**Bulletin Number: VF-014**  
**Effective: May 1, 1991**

## BOWL DEPTH: SEAT MODIFICATION

**Affected Models:** All VacuFlush® 500 and 800 series toilets, and Traveler® 500 and 900 series toilets.

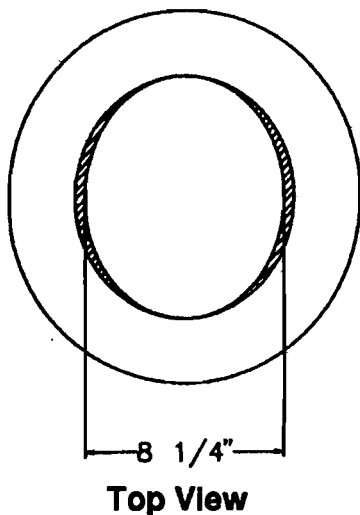
**Symptom:** Customers state "toilet is too low" or "bowl is too shallow."

**Cause:** Sometime ago SeaLand began including new plastic seat assemblies with VacuFlush and Traveler toilets in place of the older pressed wood seat and lid. Although the new seat assemblies were made of a very durable and high quality material, the shape was different than the previous wood design. The primary difference was in the width of the seat opening. It was found that some users were not being completely supported because the seat opening was too wide.

**Corrective Action:** As of July, 1990 (500 series toilets) and April, 1991 (800 and 900 series toilets) plastic seats have been modified to narrow the opening and also add additional thickness to the seat height as shown in the following illustrations. The new seat dimensions are closer to a standard household seat configuration, and offers increased comfort to most consumers.

*Shaded area represents added material to existing molds.*
